Access Compliance Report

Public Rights-of-Way

(Curb Ramps)

Intersection ID: 29226	Main Street: KORNIV_DR	Cross Street: ROZUMNY_DR	Location: NW
ADA ID: BF536CE15D63	Ramp Type: PerpDiag	Initial Pass/Fail: Fail	Overall Compliance: No
Severity Score: 12.5			
Codes/Mitigation Info/Possible Solution		Field Measurements/Component Compliance

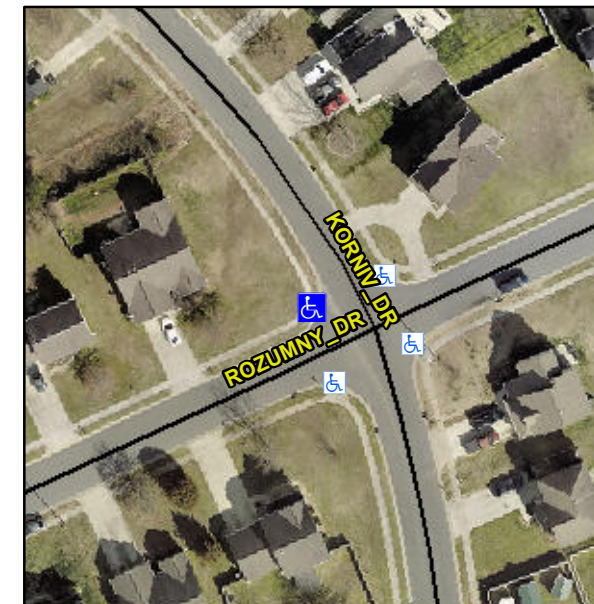
Not Found, R304.5.3

Compliance	Description	Data	Compliance	Description	Data
N/A	Ramp Length (in)	51.0	Yes	Ramp Slope (%)	5.5
Yes	Ramp Width (in)	54.0	No	Ramp XSlope (%)	6.3
N/A	Flare Type LT	N/A	N/A	Flare Type RT	N/A
N/A	Flare Slope LT (%)	N/A	N/A	Flare Slope RT (%)	N/A
N/A	Flare Traversable LT?	N/A	N/A	Flare Traversable RT?	N/A
N/A	Landing Length (in)	N/A	N/A	DWS Provided?	N/A
N/A	Landing Width (in)	N/A	N/A	DWS Contrast?	N/A
N/A	Landing Slope (%)	N/A	N/A	DWS Length (in)	N/A
N/A	Landing X Slope (%)	N/A	N/A	DWS Full Width?	N/A
N/A	Landing Curb? (Y/N)	N/A	N/A	DWS Offset (in)	N/A
N/A	Shared Landing?	N/A			
N/A	Gutter Ponding?	N/A	N/A	Gutter Slope (%)	N/A
N/A	Gutter Lip Ht (in)	0.5	N/A	Gutter X Slope (%)	N/A
N/A	Painted X Walk1?	No	N/A	Painted X Walk2?	No
	X Walk 1 Direction	To S		X Walk 2 Direction	To E
N/A	X Walk 1 Width (in)	N/A	N/A	X Walk 2 Width (in)	N/A
	X Walk 1 Slope (%)	3.6		X Walk 2 Slope (%)	1.6
	X Walk 1 X Slope (%)	3.6		X Walk 2 X Slope (%)	4.5

Remove & Replace Curb Ramp With Two New Directional Ramps or Equivalent.
